TABLE OF CHANGES FOR PLANNING AMMENDMENTS: PLAN

Project Title
T2 VITA LIVING, ST. JOHNS

Drawing Title
GROUND FLOOR PLAN

Drawing Number
6555-P-B500-P-00

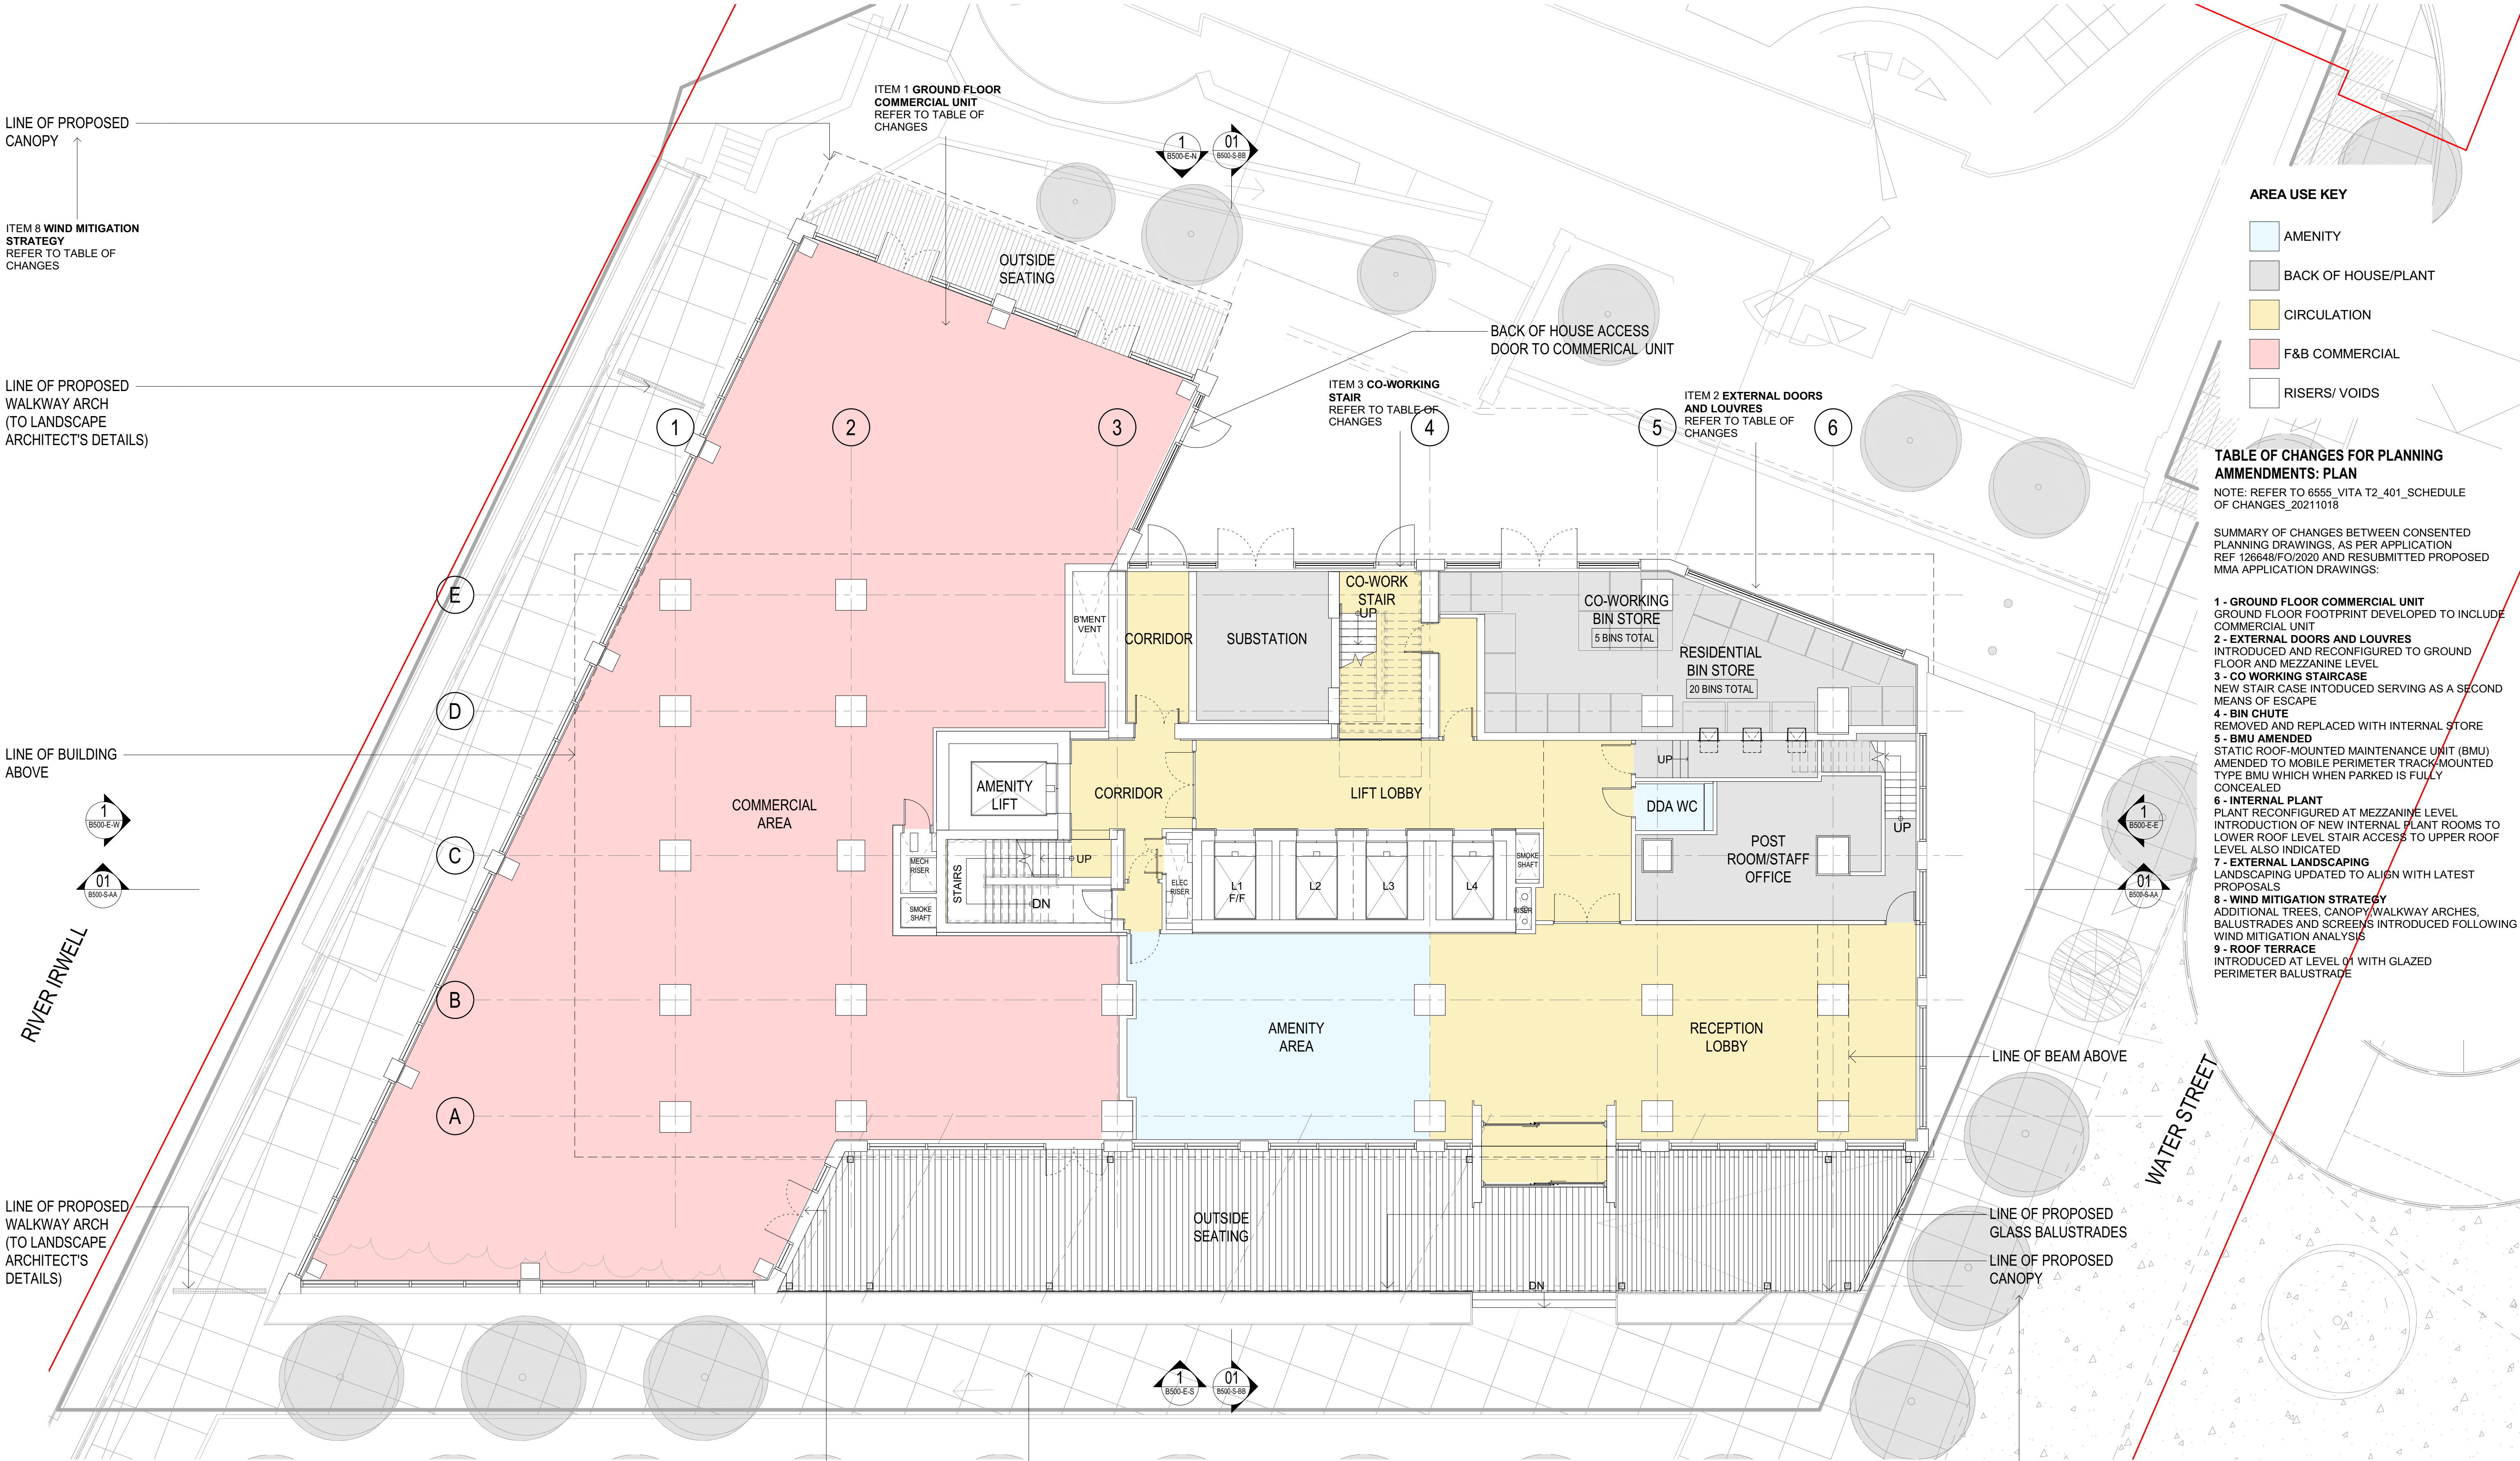
SUMMARY OF CHANGES BETWEEN CONSENTED PLANNING DRAWINGS, AS PER APPLICATION REF 126648/FO/2020 AND RESUBMITTED PROPOSED MMA APPLICATION DRAWINGS:

- 1 - GROUND FLOOR COMMERCIAL UNIT
GROUND FLOOR FOOTPRINT DEVELOPED TO INCLUDE COMMERCIAL UNIT
- 2 - EXTERNAL DOORS AND LOUVRES
INTRODUCED AND RECONFIGURED TO GROUND FLOOR AND MEZZANINE LEVEL

- 3 - CO WORKING STAIRCASE
NEW STAIR CASE INTRODUCED SERVING AS A SECOND MEANS OF ESCAPE
- 4 - BIN CHUTE
REMOVED AND REPLACED WITH INTERNAL STORE
- 5 - BMU AMENDED
STATIC ROOF-MOUNTED MAINTENANCE UNIT (BMU) AMENDED TO MOBILE PERIMETER TRACK-MOUNTED TYPE BMU WHICH WHEN PARKED IS FULLY CONCEALED

- 6 - INTERNAL PLANT
PLANT RECONFIGURED AT MEZZANINE LEVEL INTRODUCTION OF NEW INTERNAL PLANT ROOMS TO LOWER ROOF LEVEL STAIR ACCESS TO UPPER ROOF LEVEL ALSO INDICATED

- 7 - EXTERNAL LANDSCAPING
LANDSCAPING UPDATED TO ALIGN WITH LATEST PROPOSALS
- 8 - WIND MITIGATION STRATEGY
ADDITIONAL TREES, CANOPY/WALKWAY ARCHES, BALUSTRADES AND SCREENS INTRODUCED FOLLOWING WIND MITIGATION ANALYSIS

- 9 - ROOF TERRACE
INTRODUCED AT LEVEL 01 WITH GLAZED PERIMETER BALUSTRADE
